IREDELL COUNTY HEALTH DEPARTMENT

IMPROVEMENT PERMIT / AUTHORIZATION TO CONSTRUCT / OPERATION PERMIT / EXISTING SYSTEM

SUBDIVISION: Bella Crossing SECTION: 2 LOT # 41 LOT AREA: DESIGN FLOW: 480 L.T.A.R.: .3

SEPTIC SYSTEM LAYOUT - LOT 41

AS BUILT SKETCH

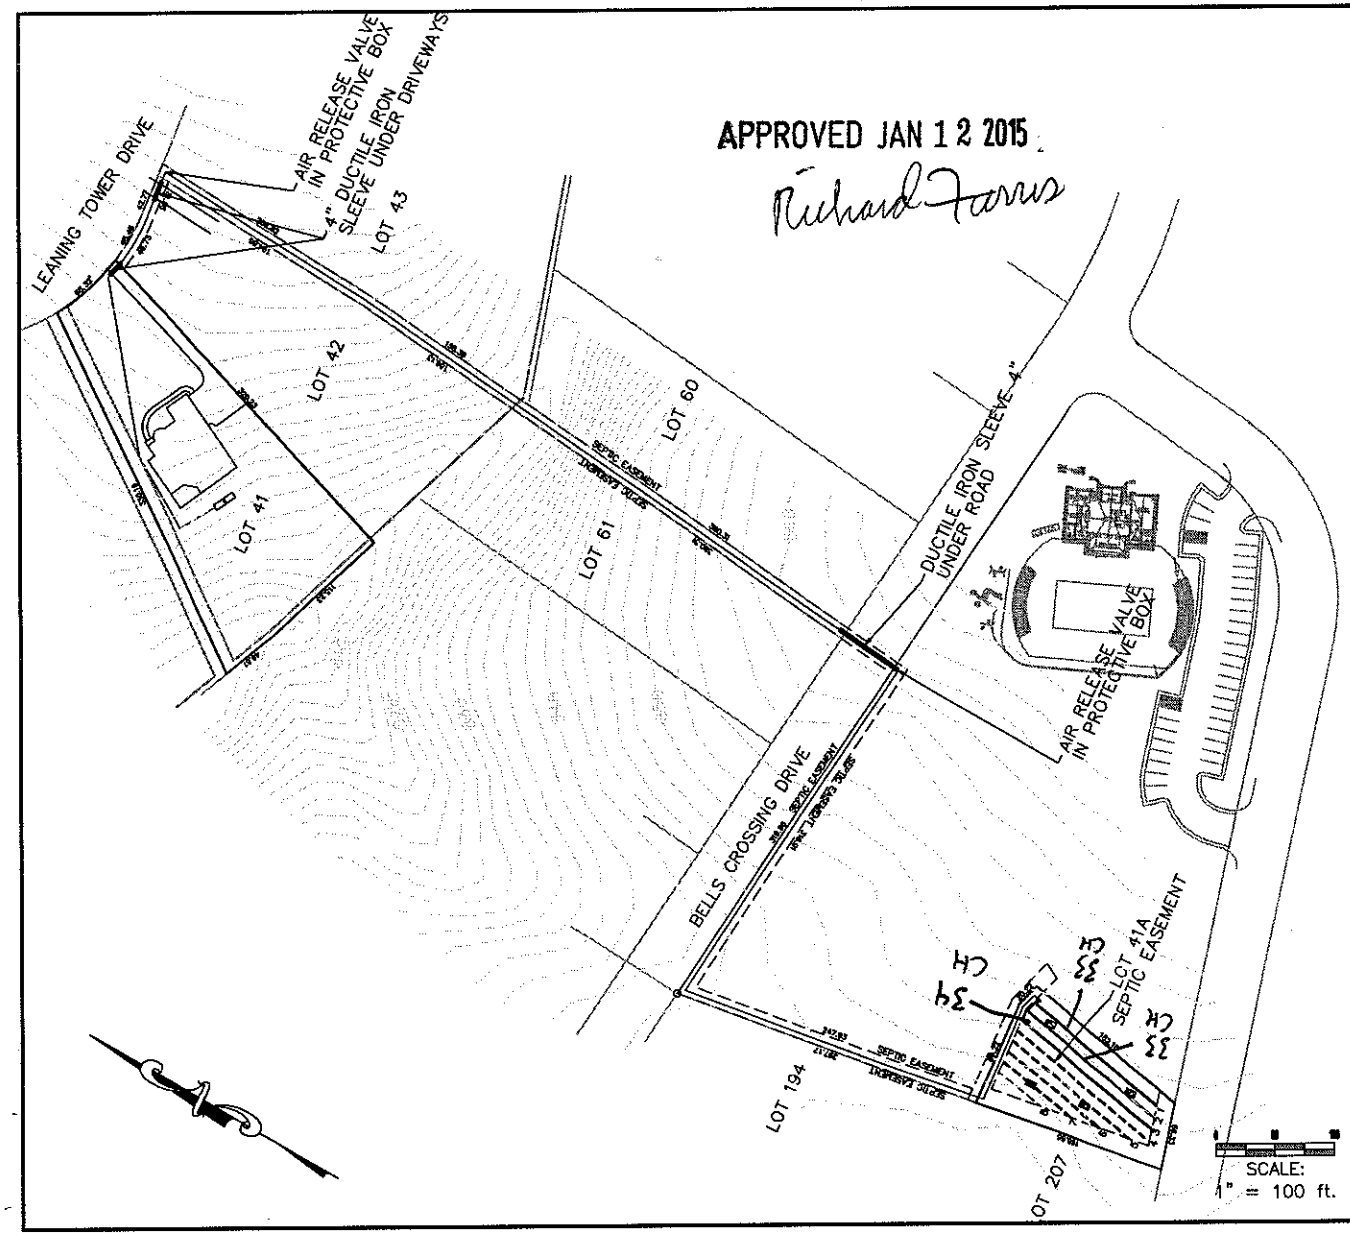
Note initial drain line area has 16"-17" of fill material on it so install drain lines @ 36" deep. Repair area had platy soil structure at 9" to 33" and some soil wetness conditions at 27" to 33". Repair panel block lines to be installed @ 58" depth beneath unsuitable soil features.

Supply Line Checked from Driveway (Depth 30"+) on Lot 42 to offsite Easement. Supply Line Depth is 30"+ under Road R/W and Sleeved in Ductile Iron Pipe. Supply Line has 18"+ vertical Separation from Water Main. Supply Line still needs to be checked on Lot 41 and about ~ 30' across front of Lot 42. SC

Water Meters need to be moved to 10' from Curb to meet 10' Horizontal Setback from Supply Line.

Checked Drain Field 11-19-15
Set 2' PH 12-3-15 SA SA

Supply Line OK 9/10/15
